From: [Susan von Hemert](#)
To: [Planning Info](#)
Subject: 635 Sagamore Road Abbutor Reply TAC Meeting
Date: Wednesday, March 27, 2024 6:08:27 PM

Meeting: TAC
RE: 100 Durgin Lane
Date: May 7, 2023

Figure 1. The proposed layout of 100 Durgin Lane with residential buildings (highlighted in yellow) and common outdoor areas (highlighted in blue).

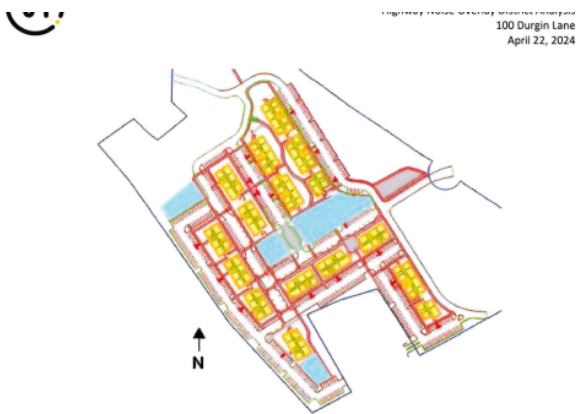
The Noise Analysis presented included many excellent details. A couple of questions not found in the report but may have been completed to be able to provide the Leq. Was model calibration done in which actual noise and traffic counts were verified vs Leq results? Were future projected noise levels calculated? Why was the north “park” not included for a sound wall since it too shows an Leq of 70 dBA and it appears closer to the Spaulding? Windows installed higher than “normal”, awning windows or no windows facing the highway would also help with reducing interior noise.

The proposed design plan has a lot of greenspace. It could help to see an overlay of the “Impervious Surface Reduction Exhibit” (pg 140). Buildings 11,10 and 13,12 could be moved southward to get the parking lot out of the 100’ Wetland Buffer and flip flop the design to put the green space on the outer side of the lot adjacent to the wetlands (C-301). This would create a continuous greenspace from the northern park along the wetlands. There is a retaining wall in the **50’ wetland buffer** which might be able to be eliminated if the parking were moved closer to the buildings and the buildings were moved, even a little, toward the center of the lot. *When living in the upper floors the view would be more pleasant as a parking lot, greenspace, wetlands, then greenspace, a parking lot and then a wetland.* The windows on the first floor could be installed higher or be awning windows to eliminate headlight glare. The spaces being “rear in parking only” could also help.
